ROLLING MEADOWS CHANNEL & FLOODPLAIN MODIFICATION

EPC STORMWATER REVIEW COMMENTS
IN ORANGE BOXES WITH BLACK TEXT

PCD-ENGINEERING REVIEW COMMENTS
IN BLUE BOXES WITH BLUE TEXT

60% DESIGN PLANS
JANUARY 2023

PLAN AND PROFILE
STA. 92+06 - 106+00

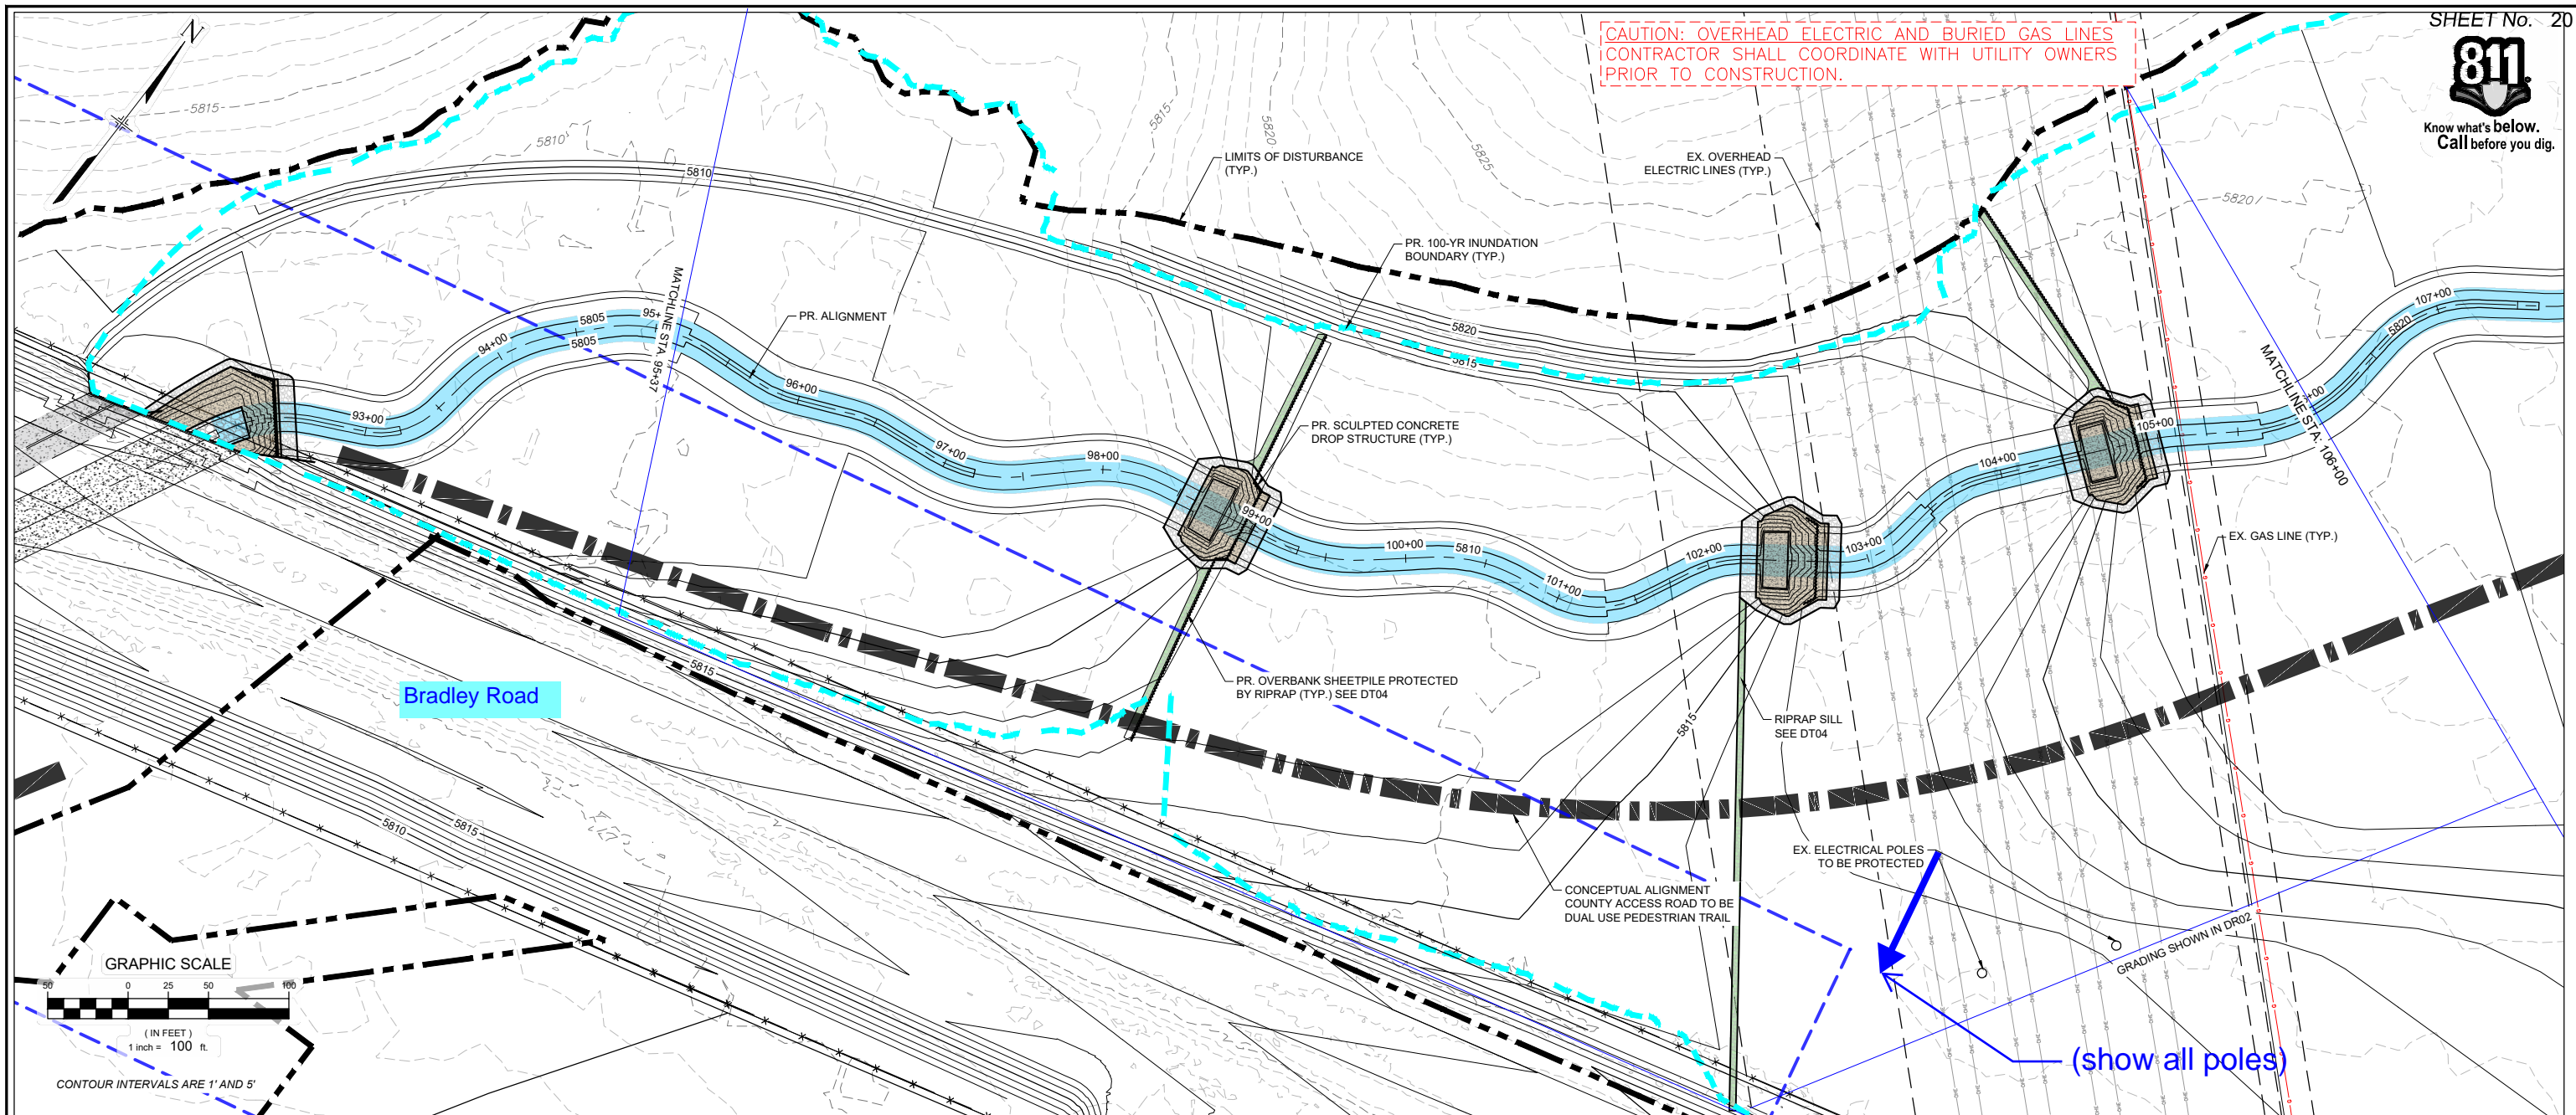
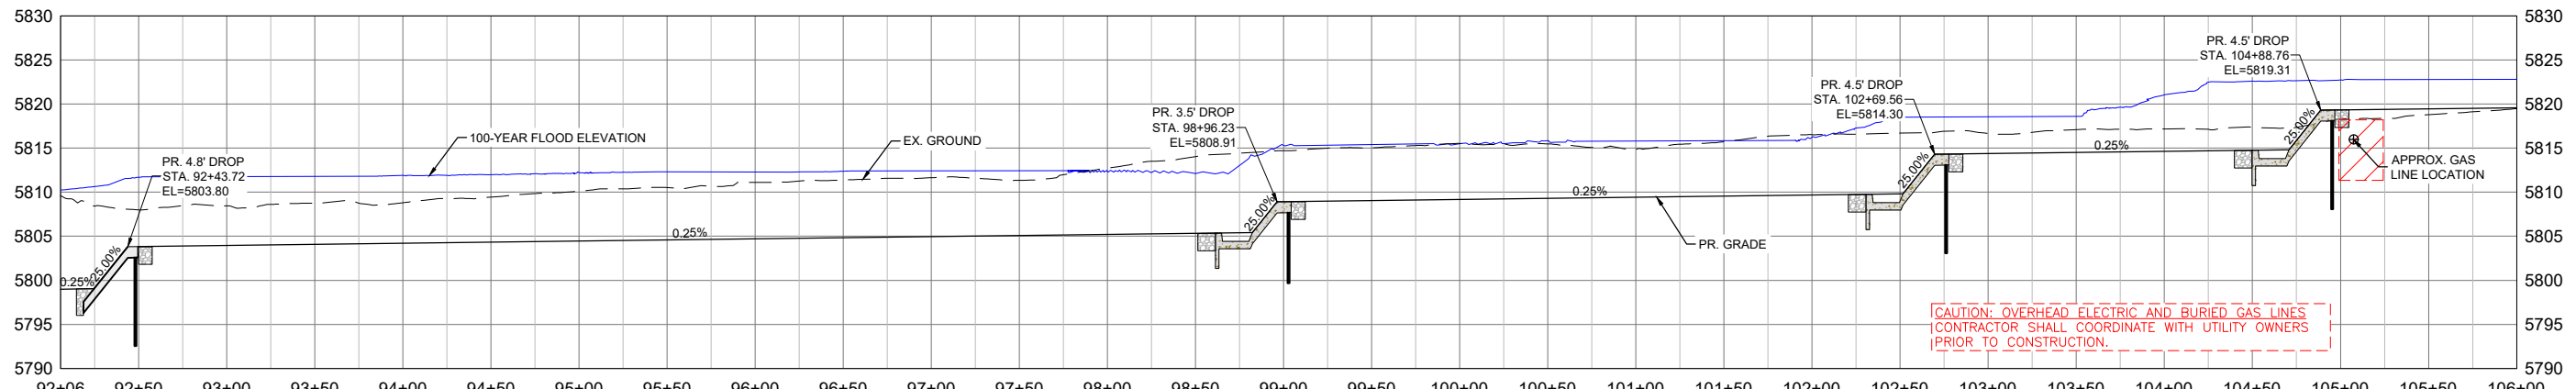
(show all poles)

PLAN AND PROFILE
STA. 92+06 - 106+00

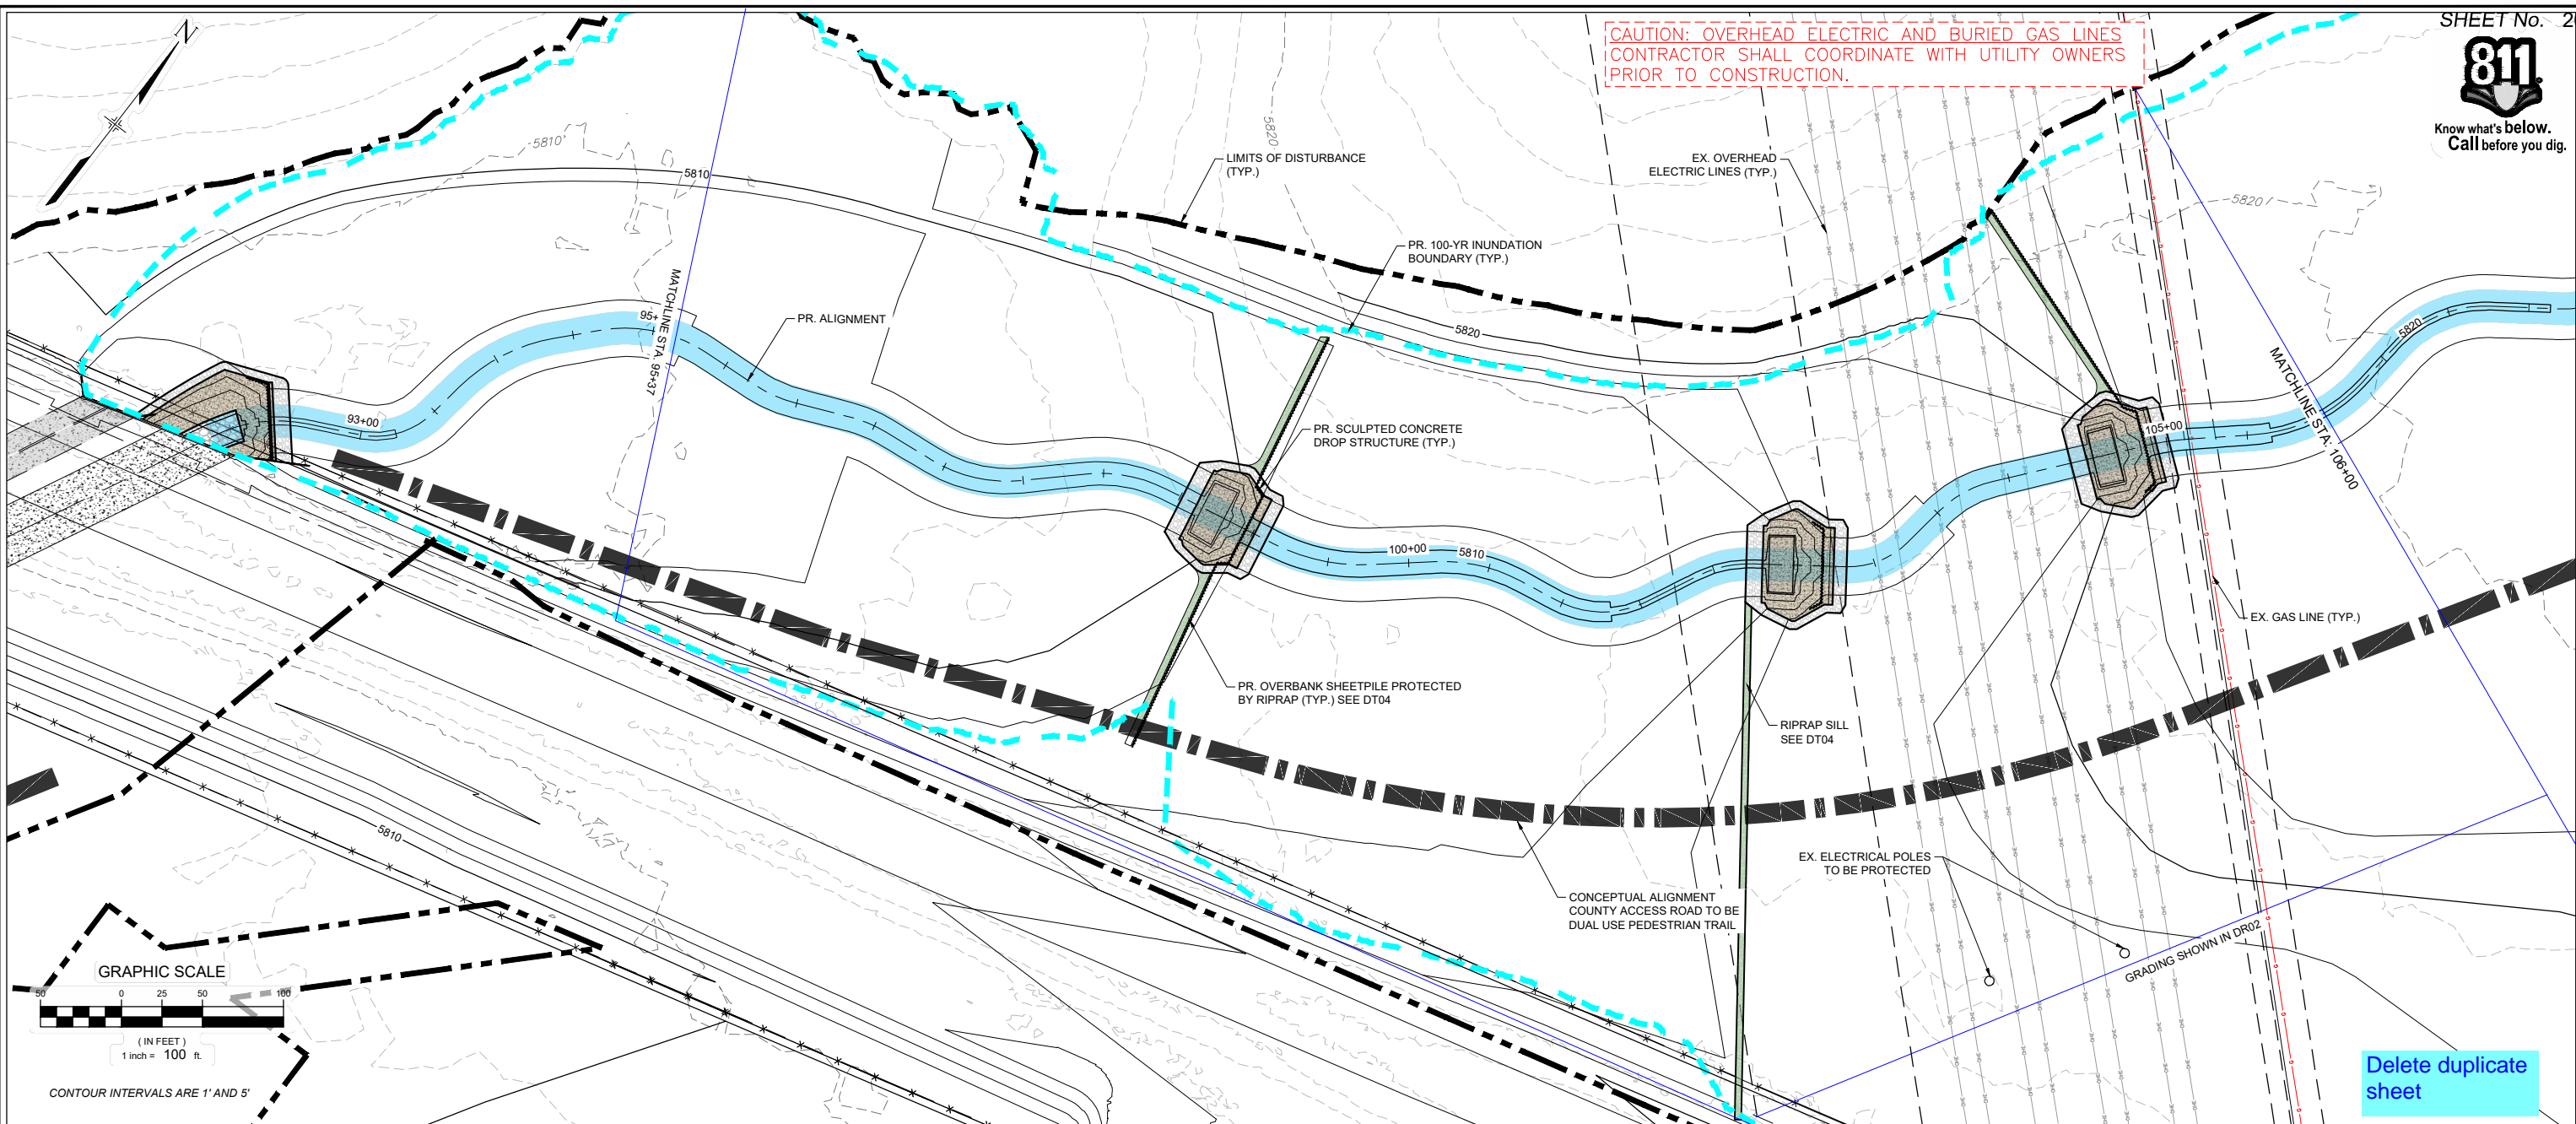
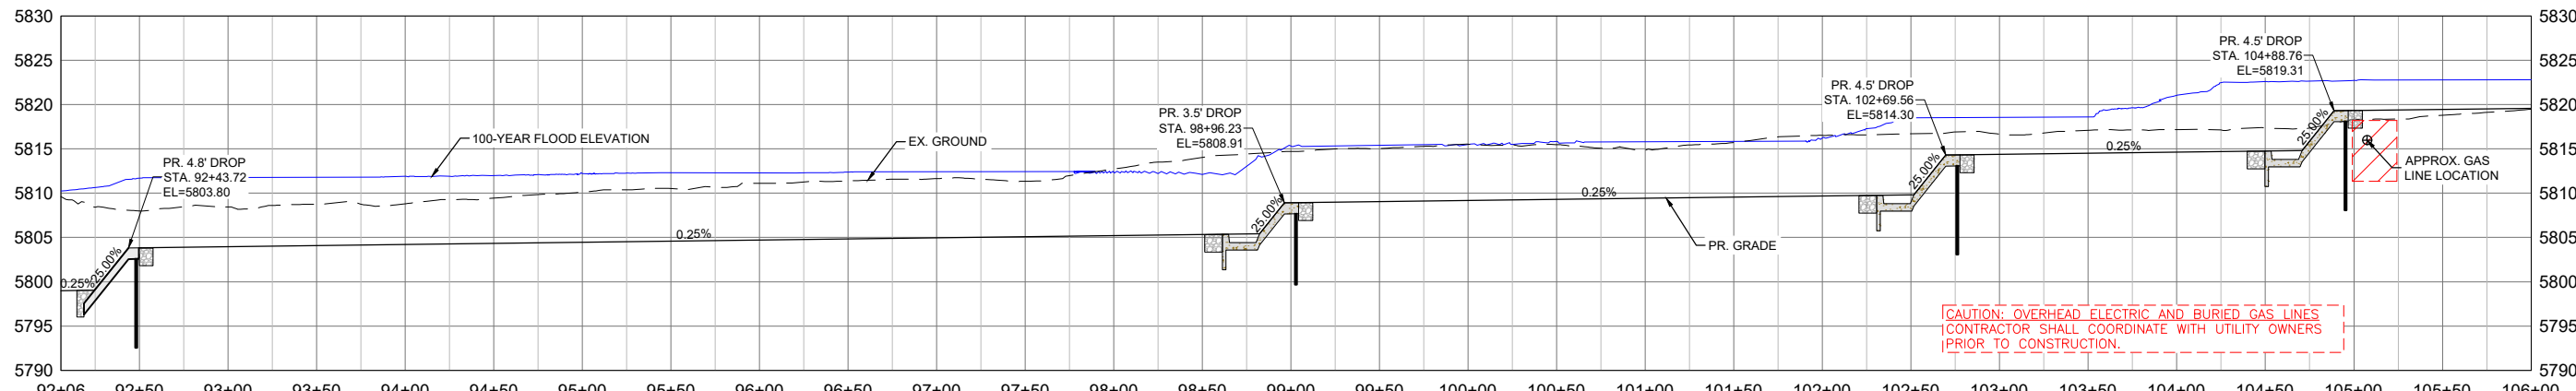
Delete duplicate sheet

| PLAN AND PROFILE STA. 160+00 - 165+00 | | | |

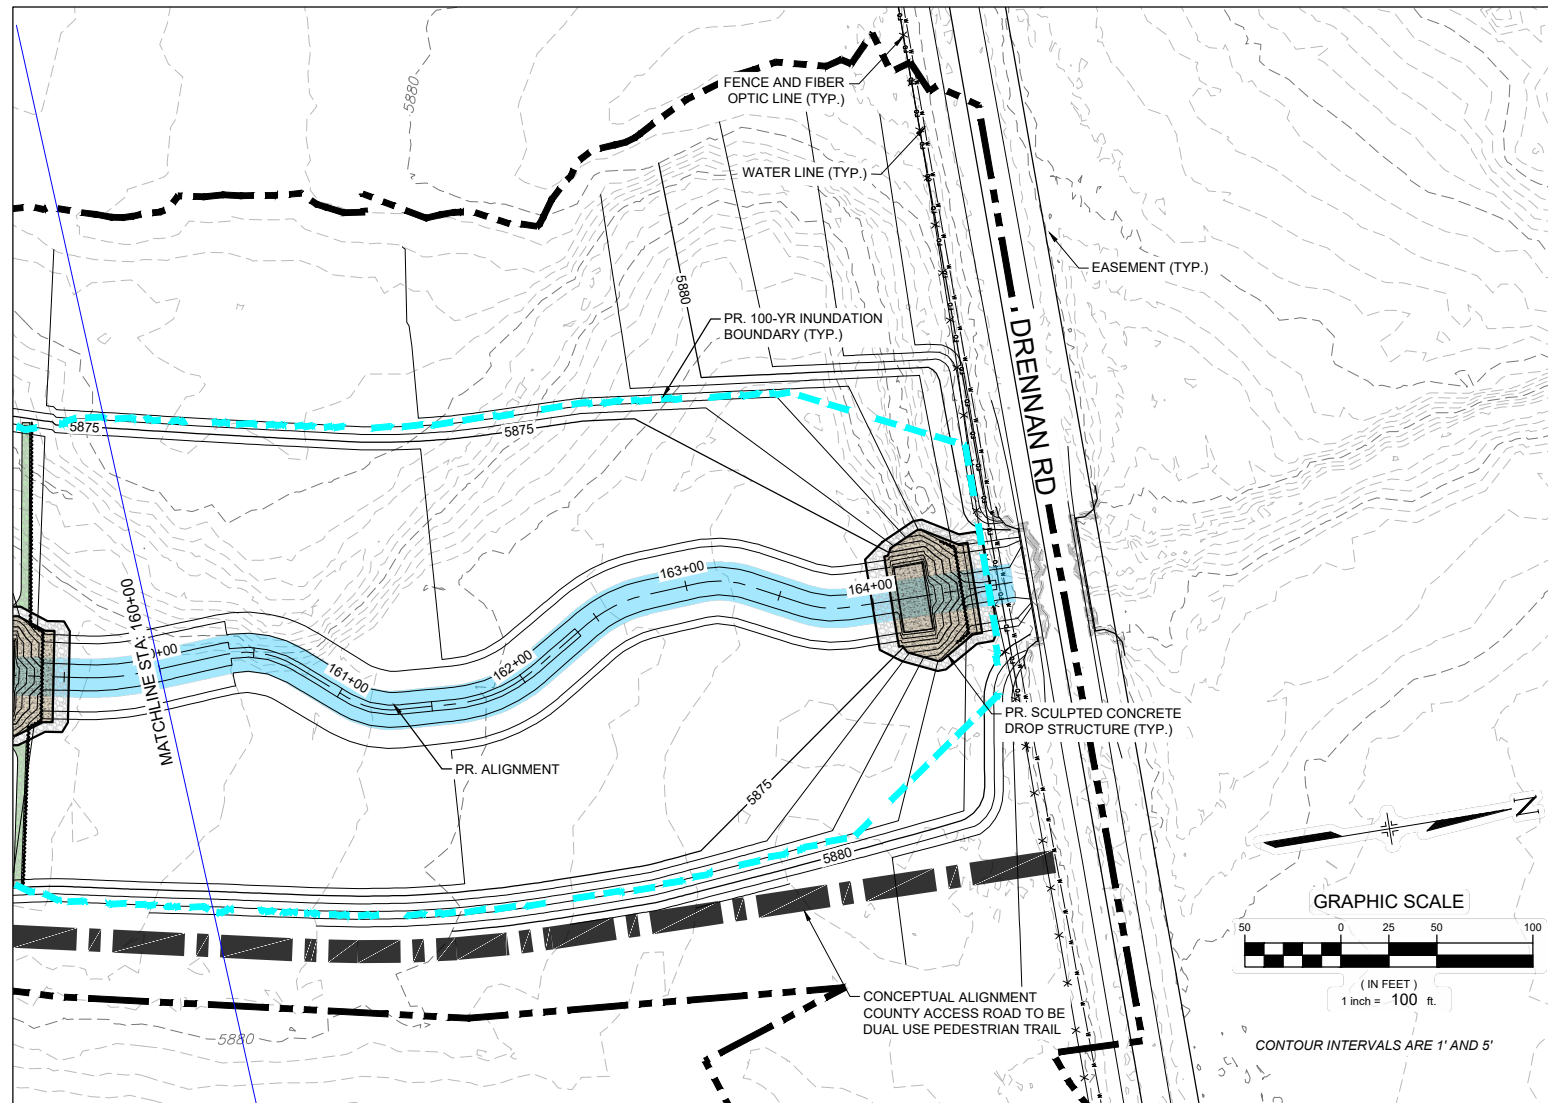
Provide a section through Drennan Road showing ROW width, pavement, shoulders, culverts etc.

CROSS SECTION VIEW - ALL DROPS (B)

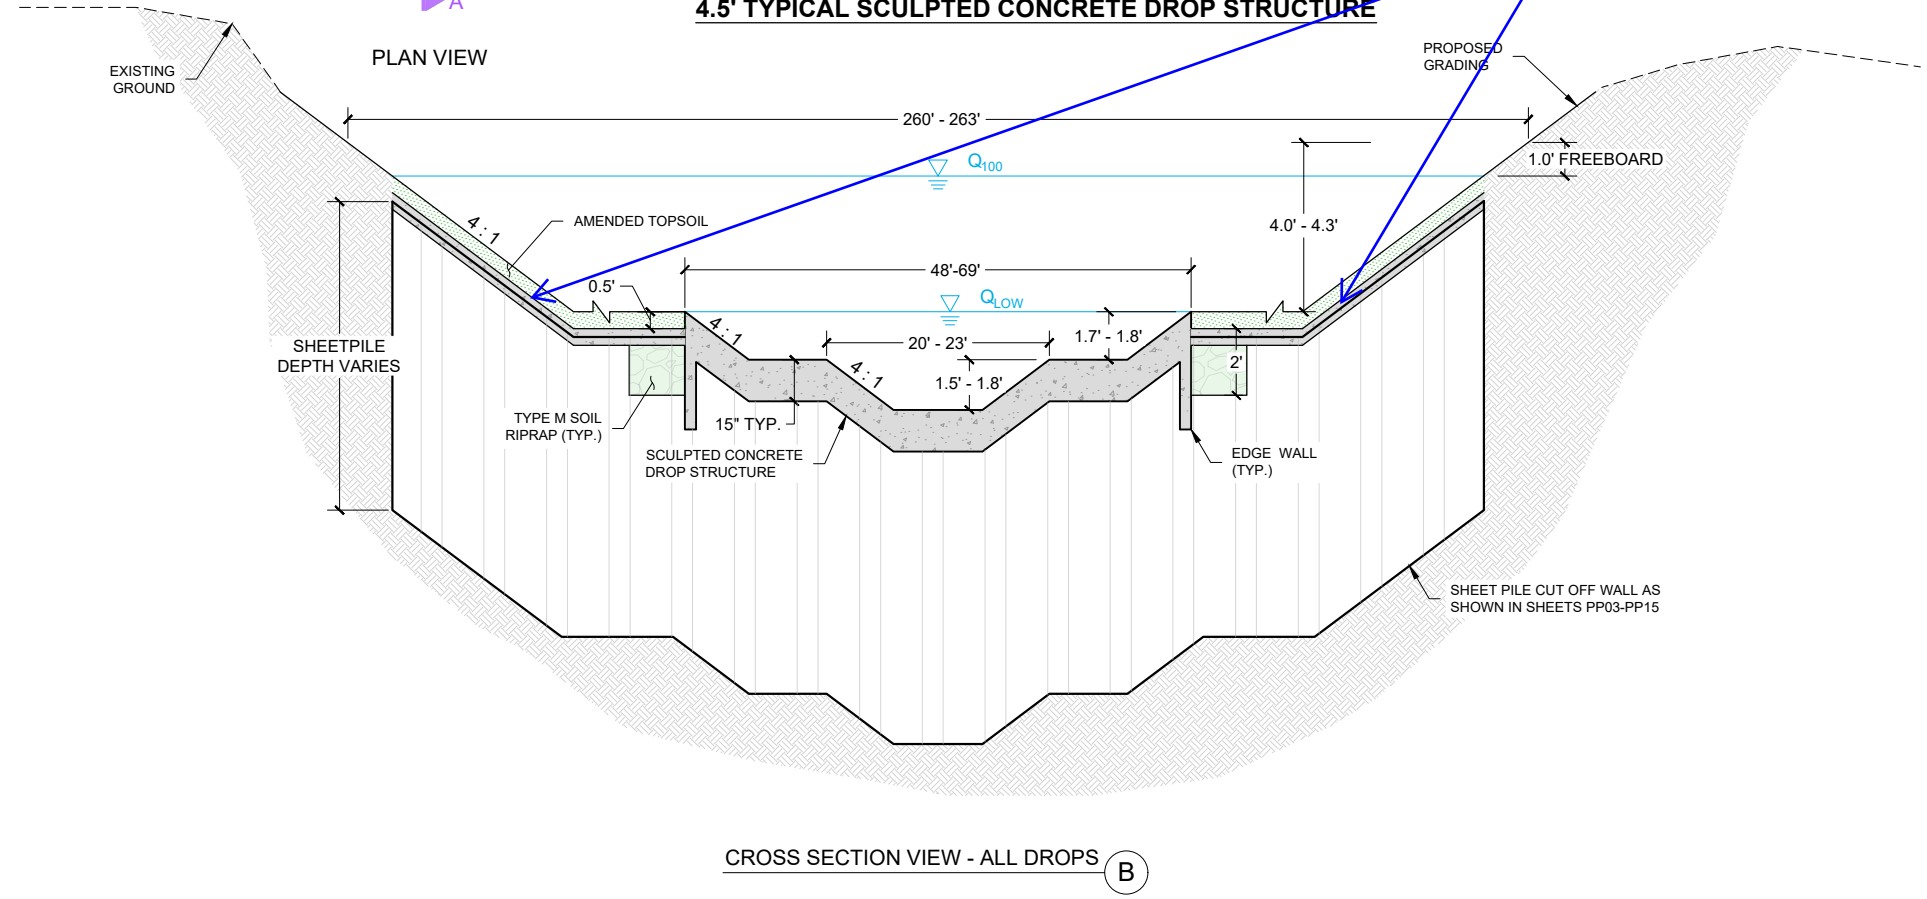
On plans it looks like only 1' of rise at the ends.
